Docket No. 50-266

Technical Specification Change No. 4
License No. DPR-24

CHANGE NO. 4 TO
TECHNICAL SPECIFICATIONS FOR
FACILITY OPERATING LICENSE NO. DPR-24
FOR POINT BEACH NUCLEAR PLANT UNIT 1
WISCONSIN ELECTRIC POWER CO.
WISCONSIN MICHIGAN POWER CO.
DOCKET NO. 50-266

FIGURE 15.2.1-1
CORE DNB SAFETY LIMITS
POINT BEACH 1 - CYCLE 2

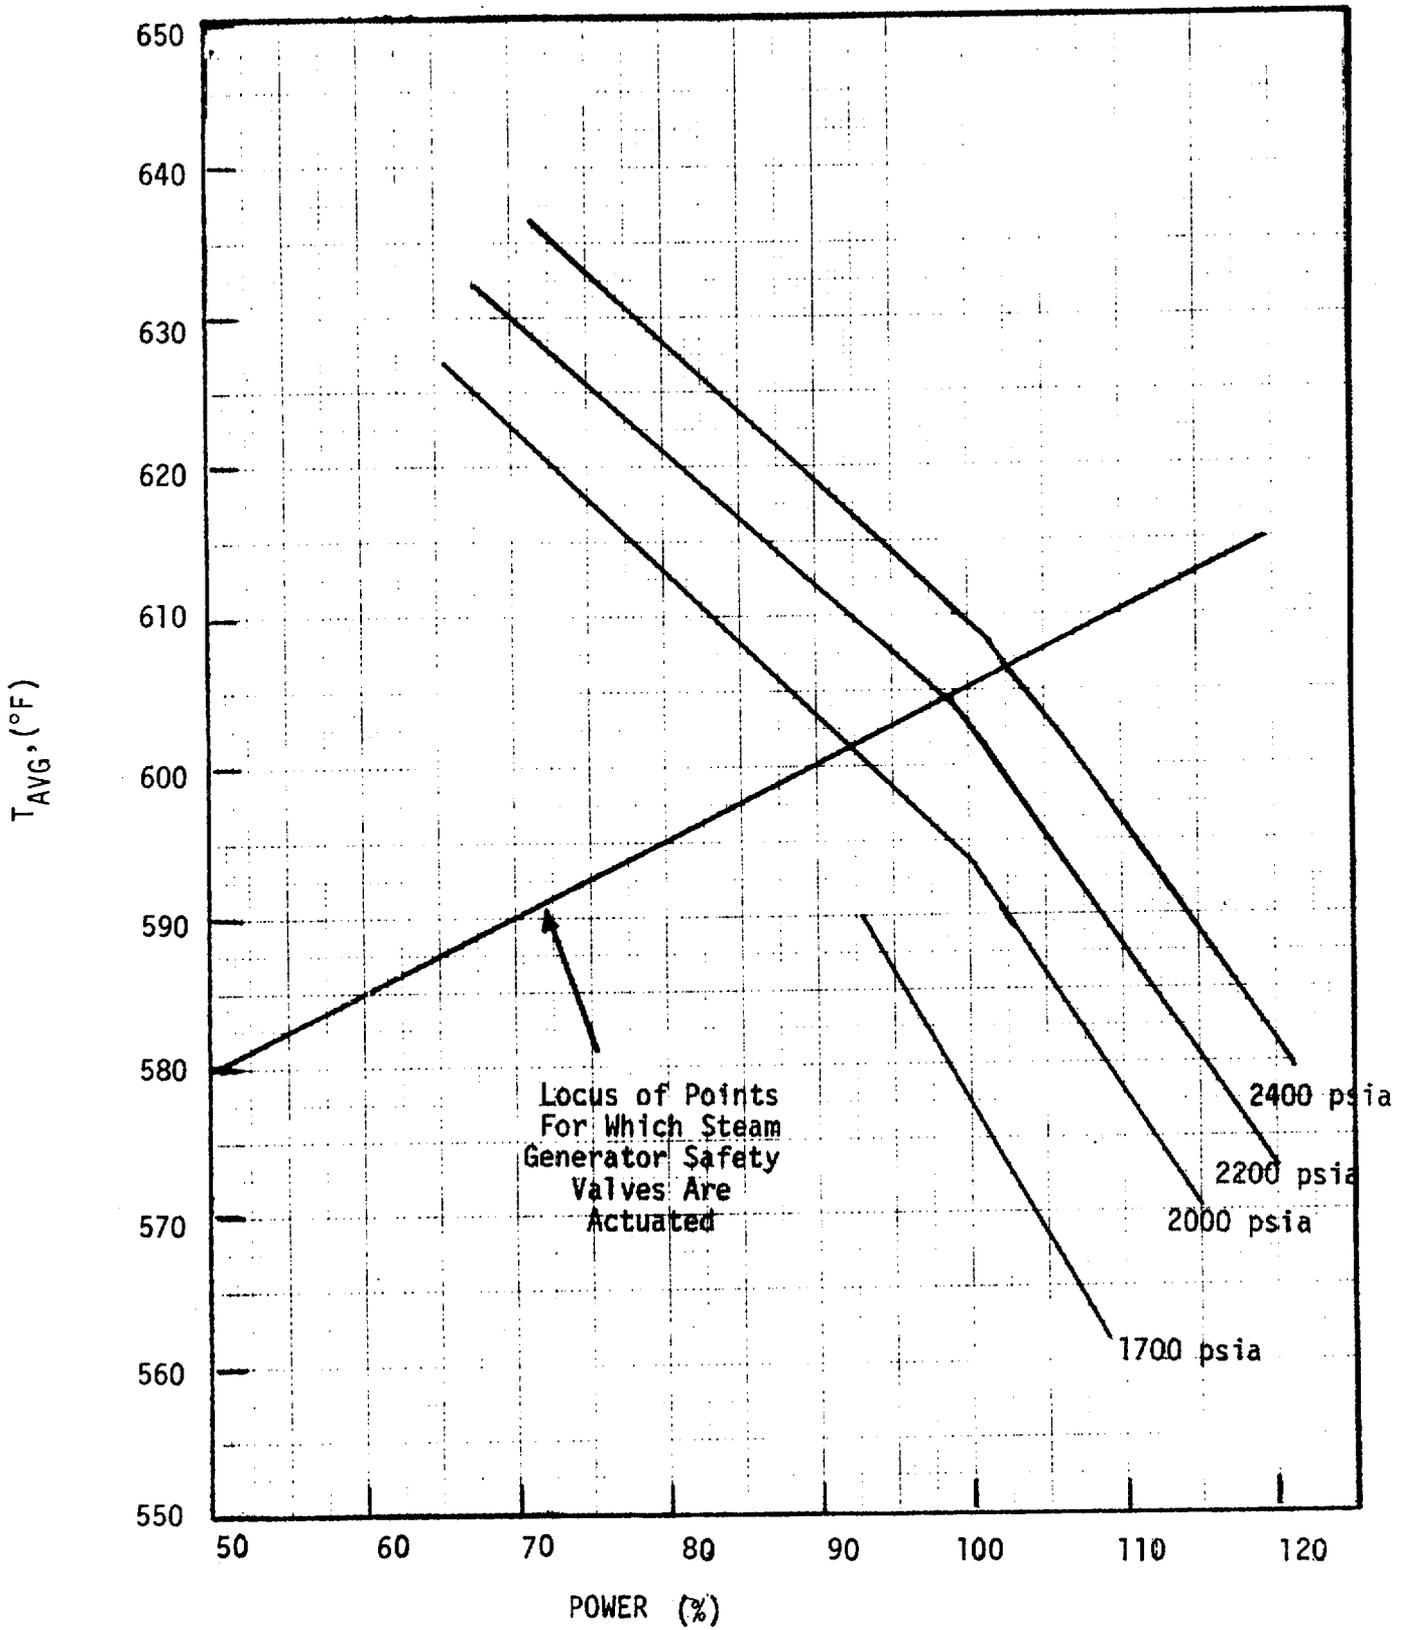
The curves of Figure 15.2.1-1 represent the loci of points of thermal power, coolant system pressure and average temperature for which the DNB ratio is no less than 1.30. The area of safe operation is below these lines. The safety limits curves have been revised to allow for heat flux peaking effects due to fuel densification and flattened fuel cladding sections.

Additional peaking factors to account for local peaking due to fuel rod axial gaps and reduction in fuel pellet stack length as well as a penalty to account for rod bowing, have been included in the calculation of the curves shown in Figure 15.2.

These curves are based on an $F_{\Delta H}^N$ of 1.58, a 1.55 cosine axial flux shape, and a DNB analysis as described in Section 4.3 of WCAP-8050 "Fuel Denficiency, Point Beach Nuclear Plant Unit 1 Cycle 2," (including the effects of fuel densification and flattened cladding).

Figure 15.2.1-1 also includes an allowance for an increase in the enthalpy rise hot channel factor at reduced power based on the expression:

FIGURE 15.3.1-1

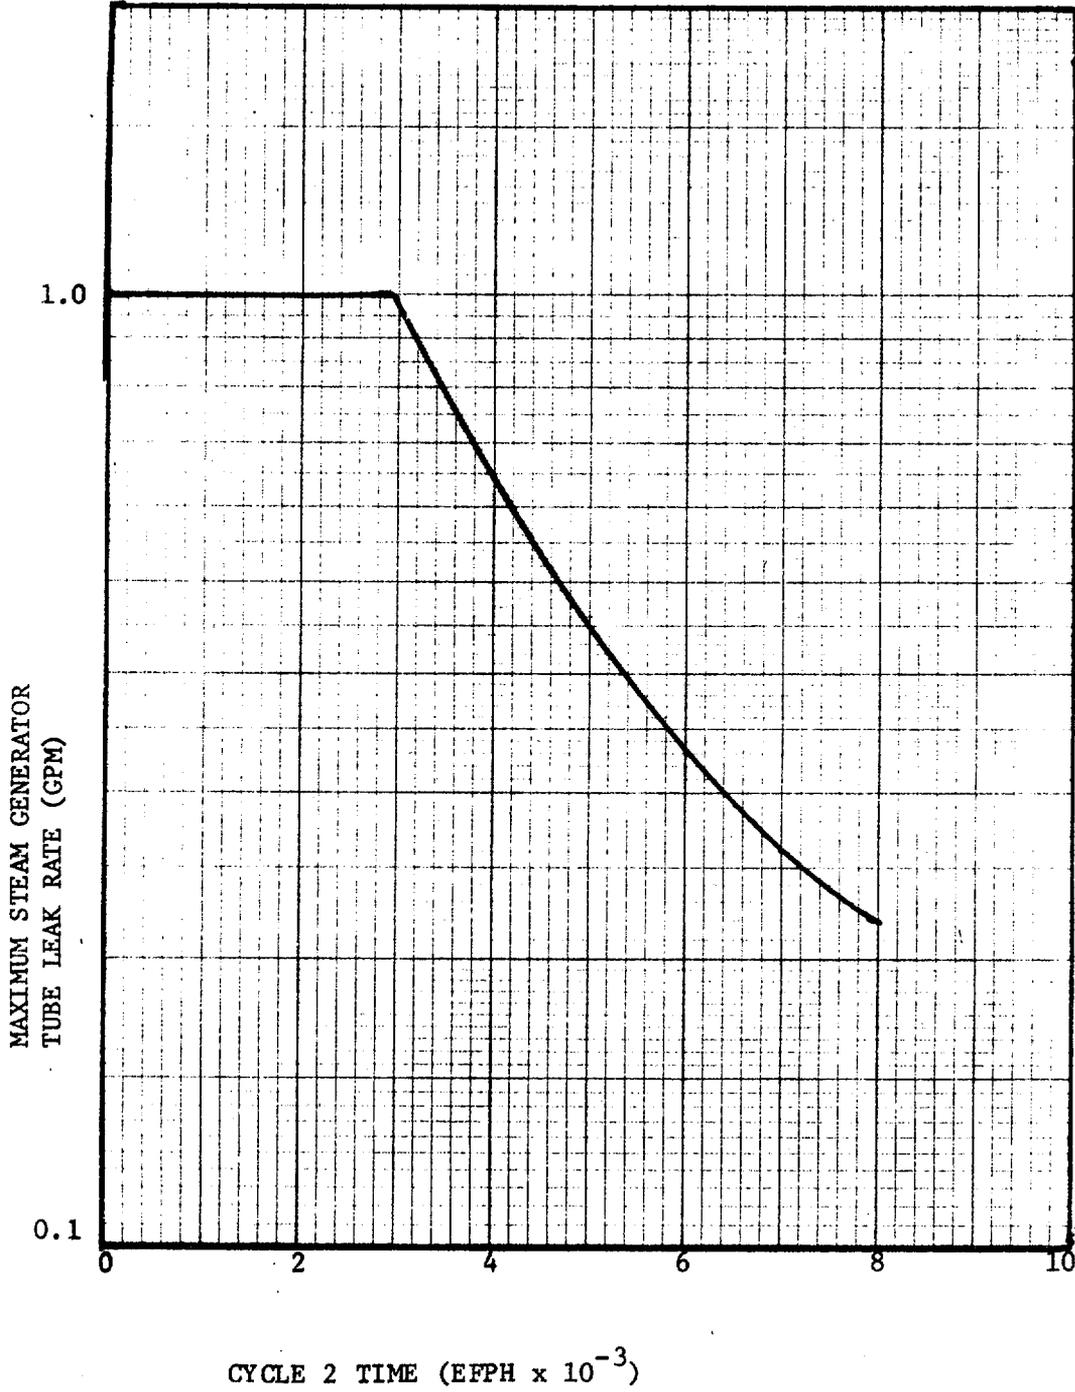
Steam generator tube leakage limits are based upon offsite dose considerations as limited by 10 CFR 20 in the event of an overpower transient with the presence of collapsed rods and 10 CFR 100 limits in the event of a steam line break or rod ejection accident.
